The Calcutta Gazette

WEDNESDAY, OCTOBER 25, 1922.

Notices to Mariners.

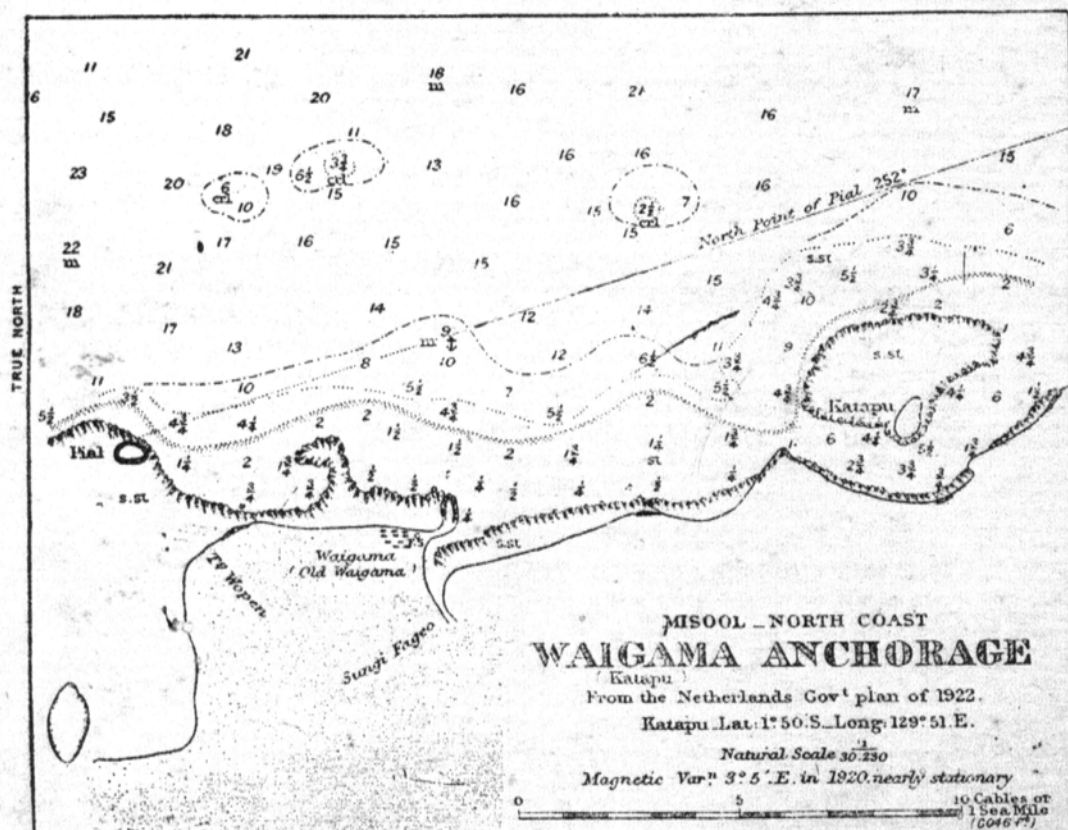
Details.—The accompanying reproduction of portions of charts, Nos. 3440 and 3744 show the necessary amendments with regard to Waigama (Katapu) anchorage. The existing plan of Katapu (New Waigama) anchorage on chart No. 3440 is to be replaced by the new plan of Waigama (Katapu) anchorage.

Reproduction of Portion of Chart N° 3726.

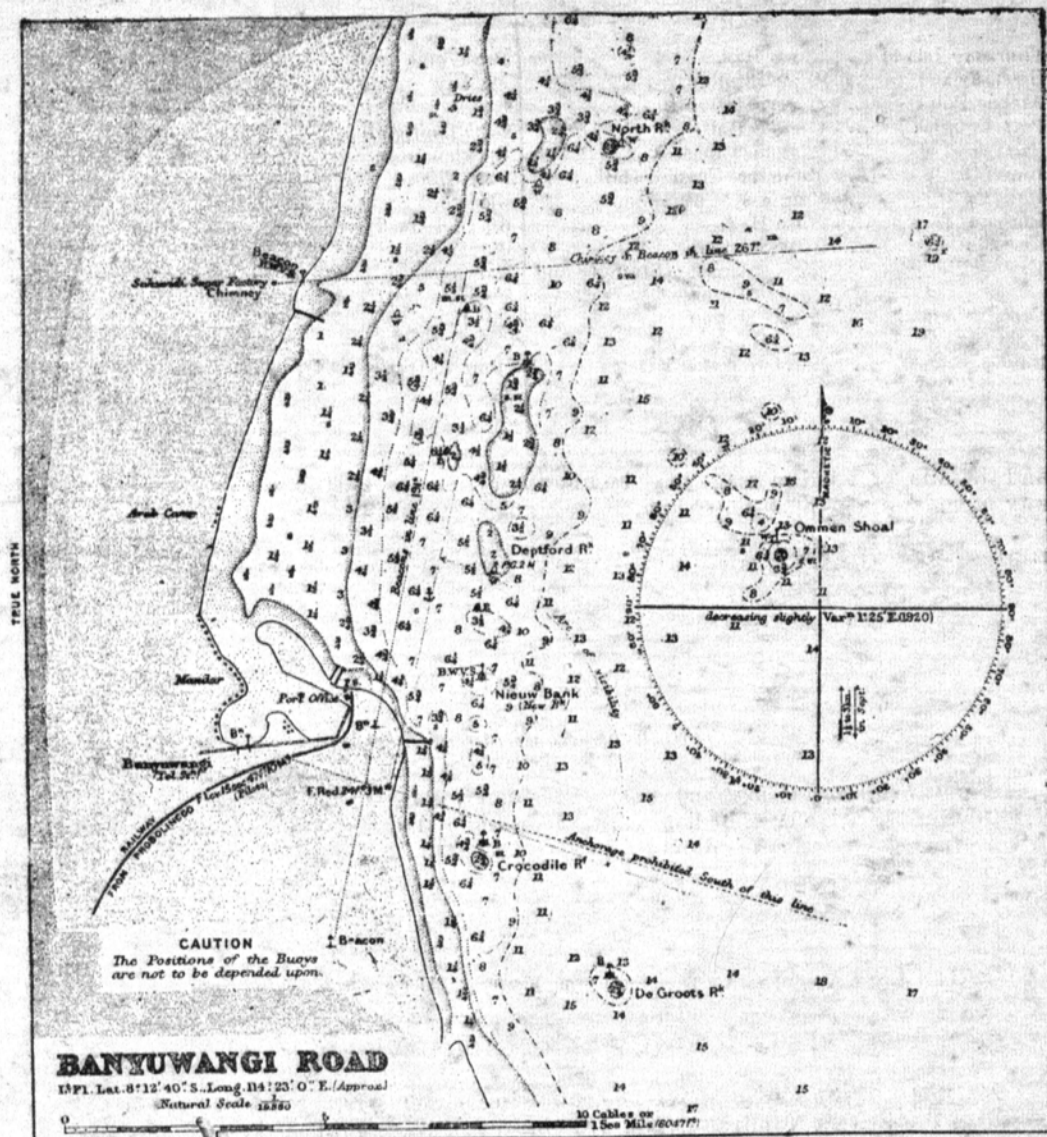
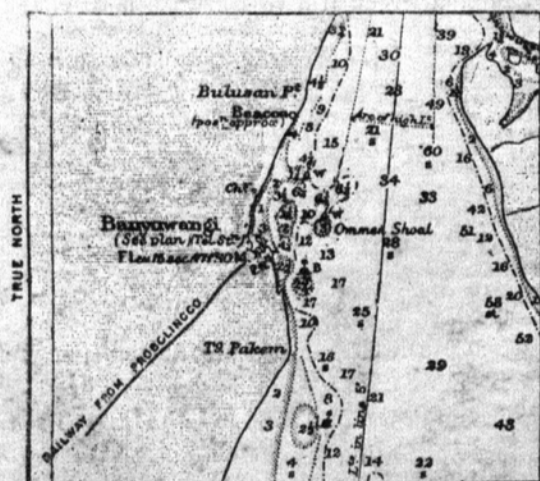
Details.—The accompanying reproduction of a portion of chart No. 3726, together with the plan quoted below, shows extensive amendments with regard to Banyuwangi road embodying the latest information received.

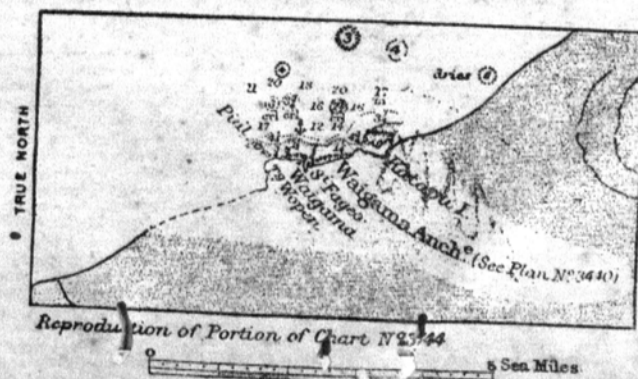
Details.—The accompanying reproduction of portions of charts, Nos. 3440 and 3744 show the necessary amendments with regard to Waigama (Katapu) anchorage. The existing plan of Katapu (New Waigama) anchorage on chart No. 3440 is to be replaced by the new plan of Waigama (Katapu) anchorage.
